IN THE MATTER of Private Plan Change 35: Te Awamutu Large Format
Retail Centre to the Waipā District Plan (**PPC 35**)

**STATEMENT OF EVIDENCE OF KEITH SHANE BELL ON BEHALF OF 638
LIMITED**

(TRAFFIC AND TRANSPORTATION)

Dated: 27 July 2026

11.34 Figure 9 of the Gray Matter report recommends various changes to the concept plan layout. I comment below on each recommended change:

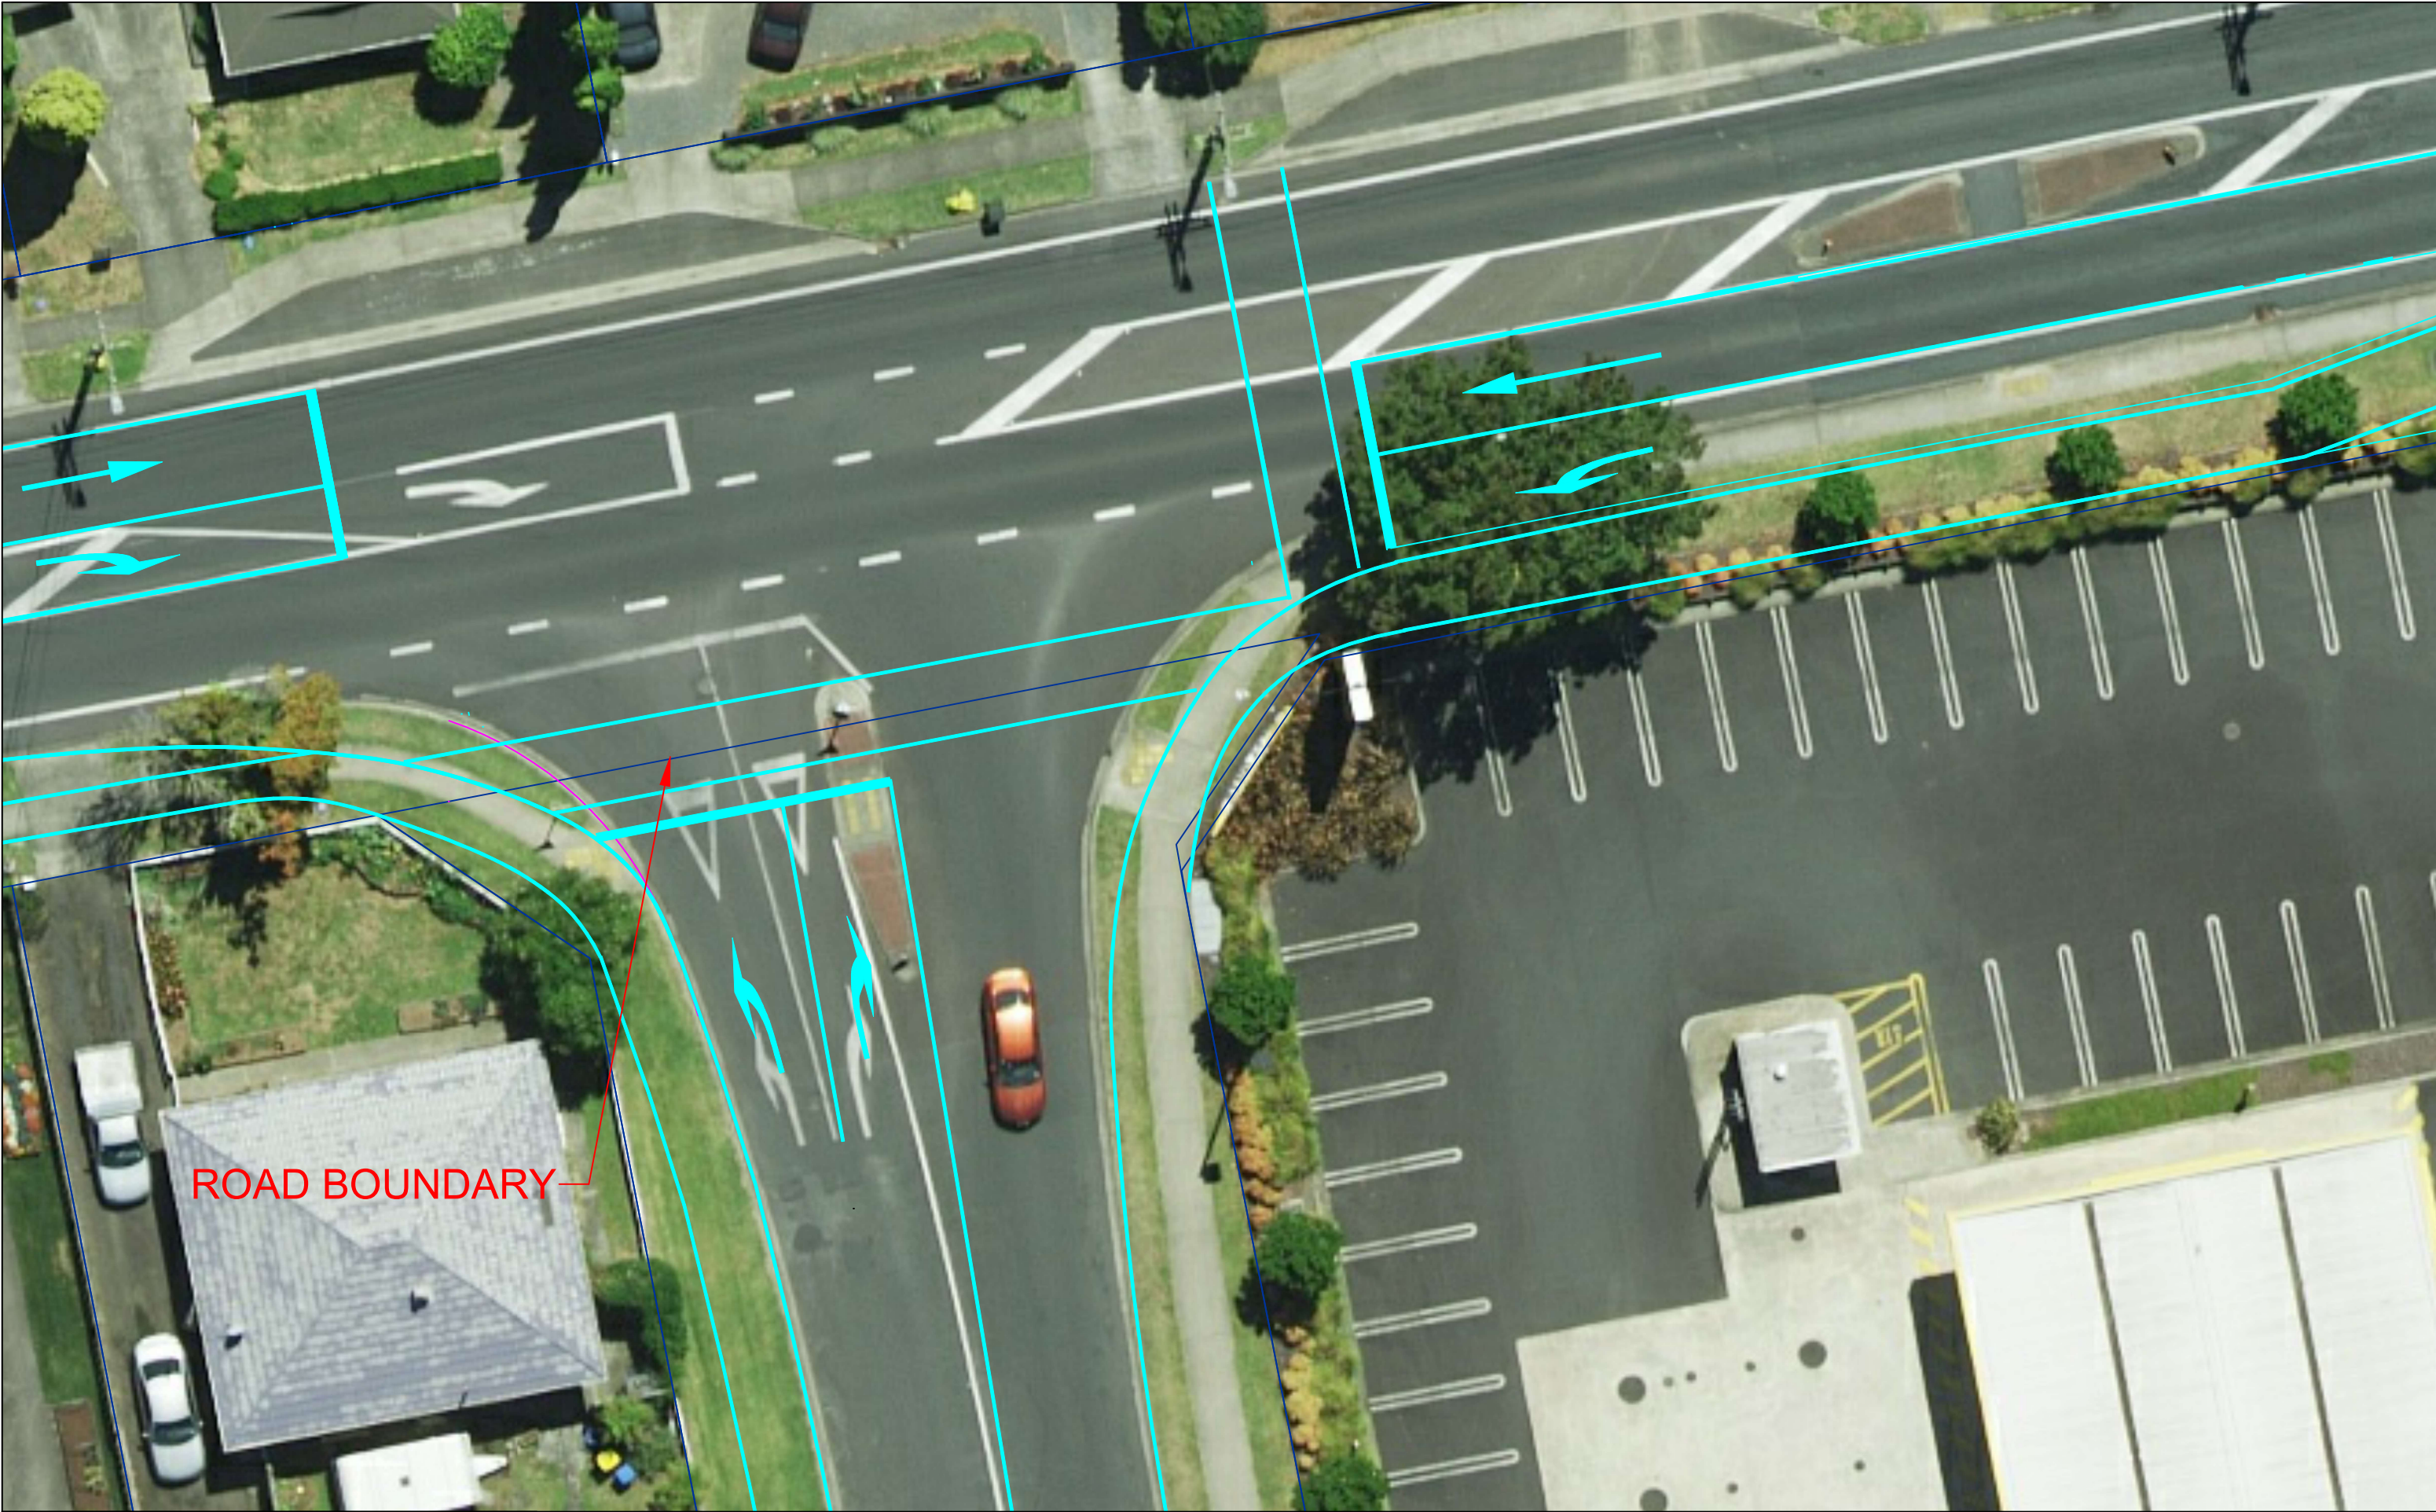
- (a) *Signalised intersection with left turn lane. Requires boundary adjustment to ensure signals are located within road reserve:*

- (b) *Provide 2.5m shared path on eastern side of private road:*

- (c) *Provide 1.5m footpath on western side of private road:*

- (d) *Provide pedestrian crossing facility on private road (e.g. refuge island). Needs to align with existing path outside supermarket:*

- (e) *Relocate vehicle crossings to provide minimum 20m separation:*

- (f) *Install no stopping lines on private road to ensure two 3.5m lanes with minimum 2.1m wide parking bays can be maintained to allow sufficient clearance to parked vehicles and opposing through movements:*

I agree with the proposed signalised intersection and left-turn lane. While I would not oppose some form of simple annotation to refer to this, I do not consider it is required, as Access 1 is the only legal access to Area B and there is no potential for confusion. I do not agree that a boundary adjustment is required.

My preference is that the existing footpath remains on the eastern side of the road, which is separated from the road and the site boundary by grass berms and landscaping

It is intended to provide a 2.5 metre wide shared path on the western side of the road.

As indicated on all plans provided to Council, it is intended to provide a pedestrian facility across the private road that connects Area A and Area B. This will need to connect with a suitable existing pedestrian route within Area A. I do not consider it is necessary to show the pedestrian facility on the Concept Plan, as its location is likely to be influenced by the final placement of the vehicle crossings serving Area B, which (as noted below) will be subject to further design and assessment through the resource consent process.

I do not agree with this recommendation. See paragraph 11.25 onwards above. The vehicle crossings shown for Area B are indicative only and will be subject to further design and assessment through the resource consent process.

The private road currently accommodates parking on both sides of the road and a generous traffic lane for each direction of travel. I do not agree that any changes are required to the existing configuration of the private road.
